PROPOSED VEHICULAR ACCESS
A57 HYDE ROAD ARDWICK MANCHESTER

Planning Application Submission
Transport Access Statement

SELCO BUILDERS WAREHOUSE, ARDWICK, MANCHESTER LEFT SLIP A57 HYDE ROAD

ROAD SAFETY AUDIT - STAGE 1

Project Code: 22333
Drawing No.: 22333_1A

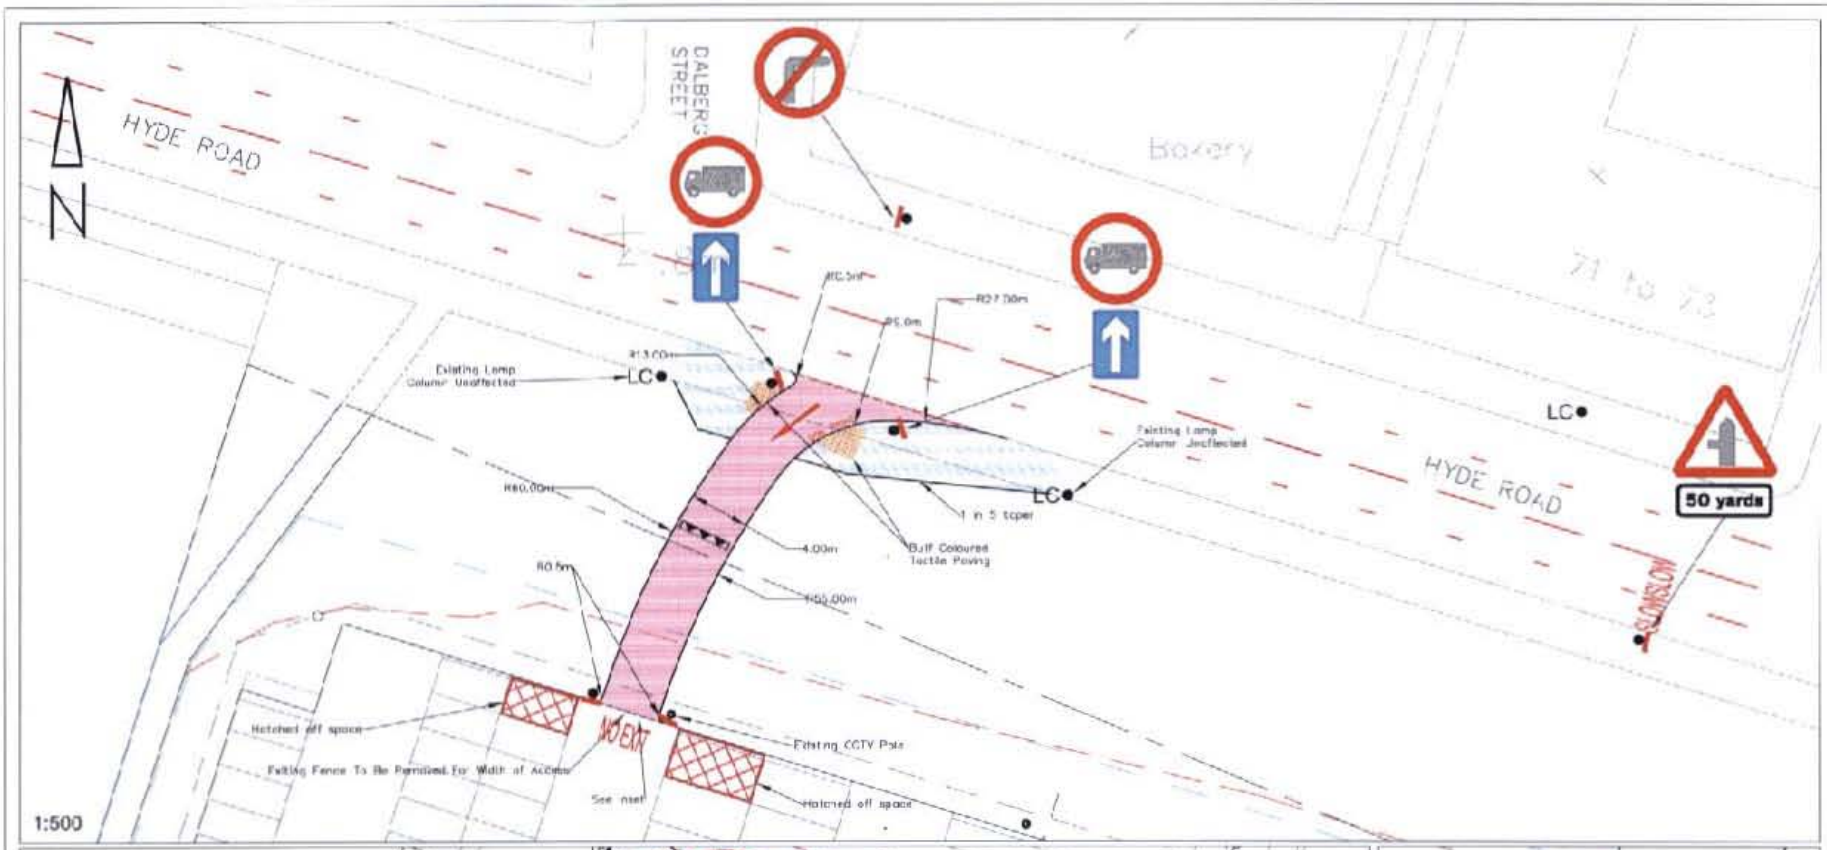
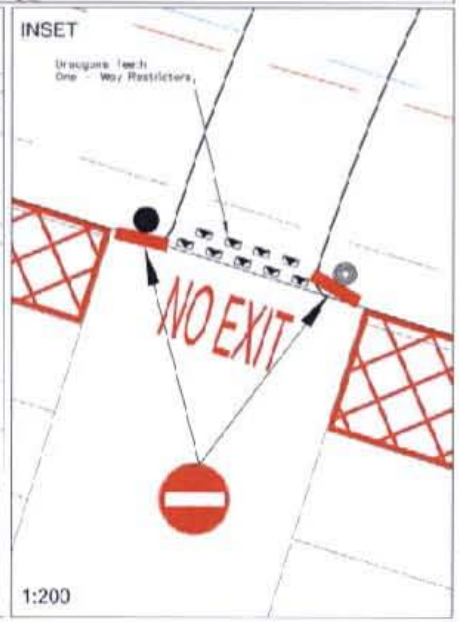
Existing vegetation should be removed or if retained should be cut back to provide adequate inter-visibility between vehicles accessing the site and vehicles manoeuvring within the central car park aisle.

The design should ensure that the pedestrian desire line does not result in any conflict with the lighting column. In addition the design of the footway should ensure that the location of the lighting column centrally within the footway should be avoided.

Arrow road markings complemented by EXIT road markings should be laid on the car park aisles informing motorists of the exist route. In addition NO EXIT road marking should be laid at the interface between the car park and new link road.

Vehicle speed restraining measures should be provided on the new link road.

The specification for the gates should ensure design integrity. In addition the design of the gates should be installed to allow the gates to open inwards, only, into the car park.

A pedestrian link should be established along the flank of the proposed new link road. Alternatively, as pedestrian access routes currently provide access to the site the proposed new link road should be designed in a manner that discourages pedestrians to walk along the new link road into the Selco car park.

The design of the new link road should be to local highway authority design standard specification in terms of pavement construction, drainage and profiles.

Inter-visibility is to be improved by ensuring that the canopy of the tree does not obstruct the inter-visibility between vehicles on the new link road and vehicles approaching the new link road from the east. The tree should be pruned accordingly.

The recommendation is accepted. Existing vegetation will be trimmed / pruned accordingly. In addition one car parking will be removed at either side of the existing car park aisle immediately adjacent to the boundary.

The design has been amended accordingly with the realignment of the tactile paving and tapering of the widened footway to avoid pedestrians walking into the existing lighting column.

Recommendation accepted and details will be incorporated into the design during detailed design stage,

Recommendation accepted. Speed restraint measures will be incorporated under detailed design and as part of the Highways Act 1980 – Section 278 process.

Recommendation accepted. An appropriate gate will be installed that opens inwards into the site.

Recommendation not accepted.

- It is unlikely that customers will enter the premises as pedestrians.
- All staff use cars to access the site and will be instructed not to use the new link as a pedestrian access.
- The link road will form an access to a private development that does not provide a service for the general public.
- An existing pedestrian access runs along the western boundary of the site leading to the main entrance.

Recommendation accepted. All detailed design aspects to be agreed under the Highways Act 1980 – Section 278 agreement.

Recommendation accepted. However, as the existing tree already causes an obstruction when in full foliage discussions will need to take place with the local highway authority regarding obligations and responsibilities in the maintenance of the tree.

RSA FIGURE 1

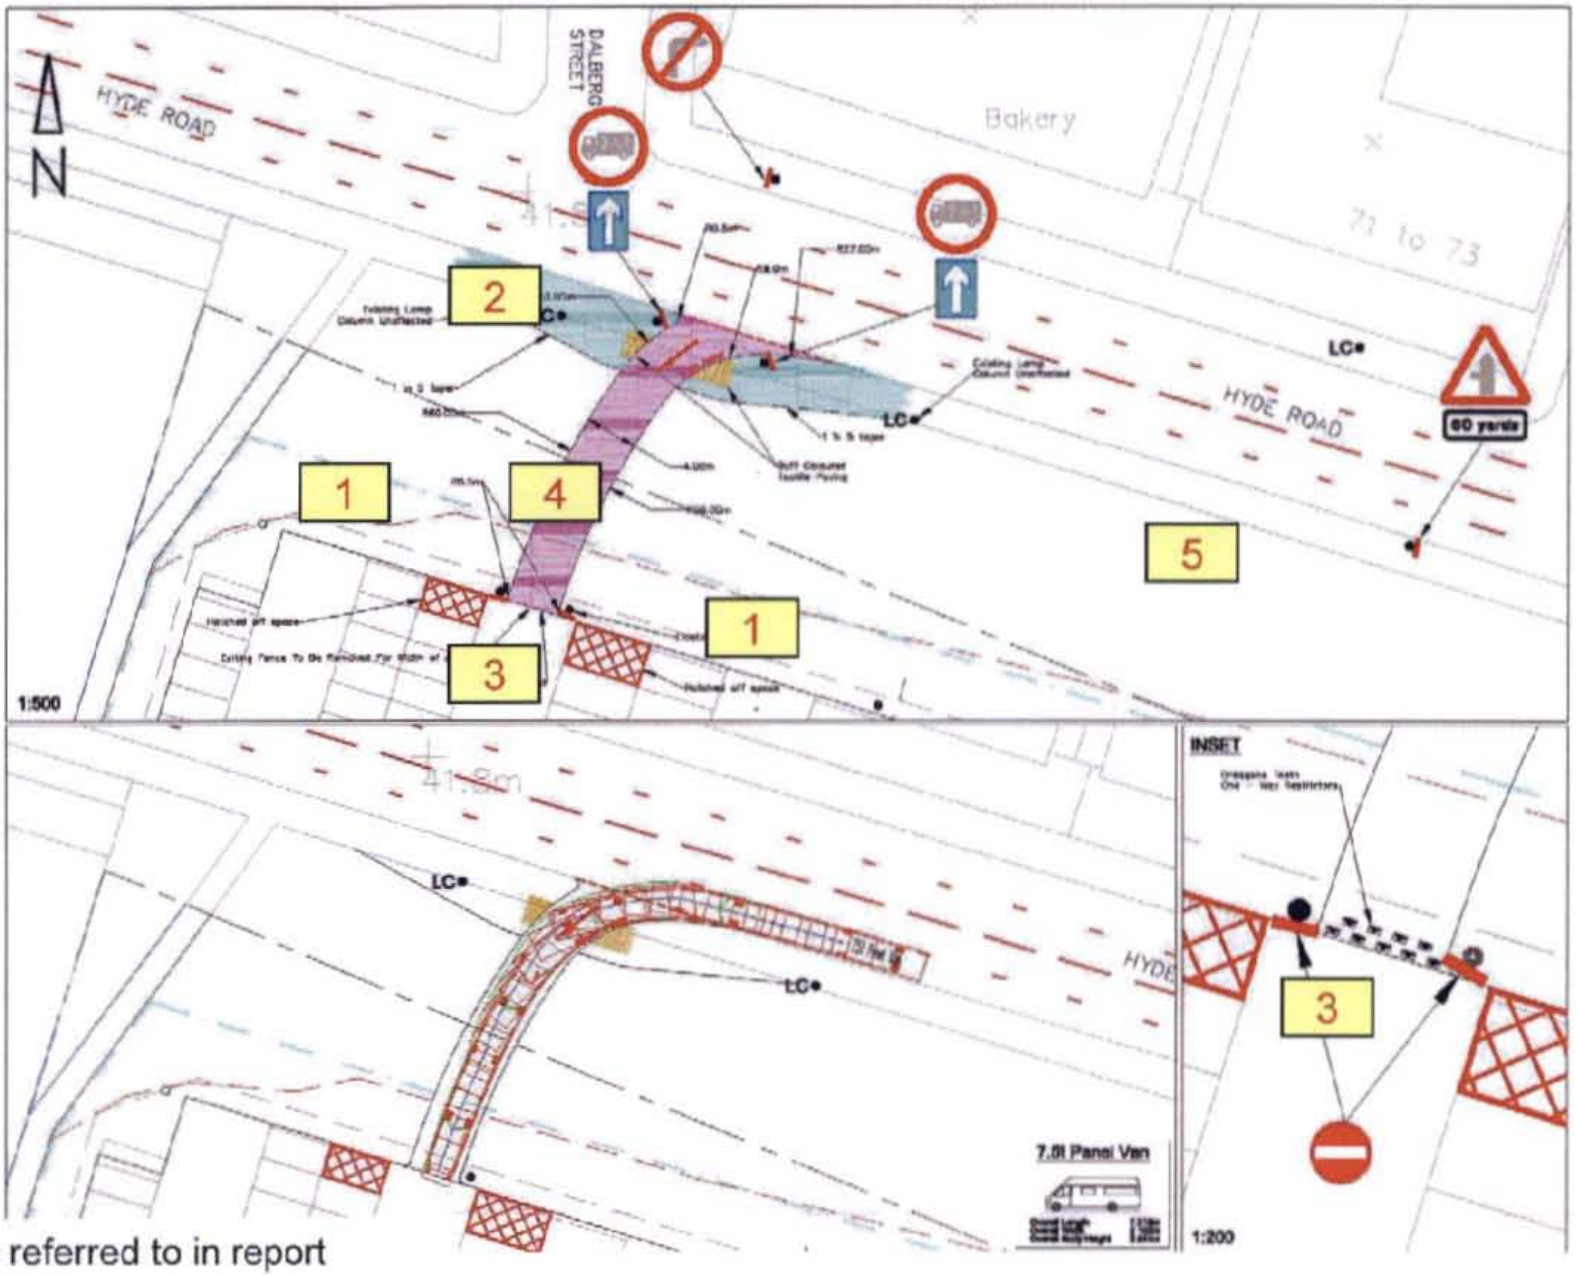
Summary: Restricted inter-visibility due to presence of vegetation.

On inspection of the site existing vegetation runs along the line of the existing fence. From the drawings submitted to the audit it is not clear whether the vegetation will be removed or retained.

The audit team is concerned that any vegetation located to both flanks of the access, particularly in summer months, could restrict the inter-visibility between motorists accessing the site and vehicles manoeuvring from car parking spaces resulting in potential vehicle and pedestrian conflicts.

Existing vegetation should be removed or if retained should be cut back to provide adequate inter-visibility between vehicles accessing the site and vehicles manoeuvring within the central car park aisle.

Summary: Public Lighting Column / Realigned Footway

The audit team is concerned that a section of footway located to the west of the proposed access has been tapered resulting in an existing lighting column being located within the useable footway. Taking into account the location of the lighting column and the alignment of the proposed footway dropped crossings with associated tactile paving pedestrians will be directed into the path of the lighting column causing a collision particularly for those pedestrians that are visually impaired and or the blind.

The design should ensure that the pedestrian desire line does not result in any conflict with the lighting column. In addition the design of the footway should ensure that the location of the lighting column centrally within the footway should be avoided.

Summary: New Access link into Selco Car Park

The details submitted on drawing "22333_1 LEFT IN ONLY indicate that two "No Entry" signs will be located to each side of the new road to prevent vehicles entering the access road from the car park. In addition Dragons Teeth One-way Restrictors are proposed.

The audit team considers that vehicles may attempt to access the A57 Hyde Road resulting in conflict at the interface between the car park and new link road.

Arrow road markings complemented by EXIT road markings should be laid on the car park aisles informing motorists of the exit route. In addition NO EXIT road marking should be laid at the interface between the car park and new link road.

Summary: New Entry into Selco Car Park

The audit team is concerned that the approach speeds of vehicles entering the new link road, from the A57 Hyde Road ,may be high resulting in gravitational pull of vehicles towards the outside of the new link road entry radius resulting in a loss of control accident. In addition the new link road could encourage high vehicle speeds on entry into the car park.

Vehicle speed restraining measures should be provided on the new link road.

Summary: Drainage, Longitudinal and Cross Section details

The drawings supplied to the audit do not include any drainage, longitudinal and or cross sectional details for the new link road. The audit team has been unable to assess the impacts of such design parameters on road safety.

The design of the new link road should be to local highway authority design standard specification in terms of pavement construction, drainage and profiles.

Summary: Reversing Vehicles into the A57 Hyde Road

The audit team is concerned that should the gates be closed and a vehicle arrives at the gates this vehicle will be required to reverse back into the A57 Hyde Road. The audit team is concerned that such a vehicle will reverse at a point where sight lines to the east are restricted by an existing tree located close to the back edge of footway.

In addition this tree will restrict the forward visibility on approach to the new link road when travelling east to west along the A57 Hyde Road in the inside lane.

The audit team is concerned that a potential exists for a vehicle that would be required to reverse from the new link road to collide with a vehicle approaching the new link road junction when travelling from the east.

Inter-visibility is to be improved by ensuring that the canopy of the tree does not obstruct the inter-visibility between vehicles on the new link road and vehicles approaching the new link road from the east. The tree should be pruned accordingly.
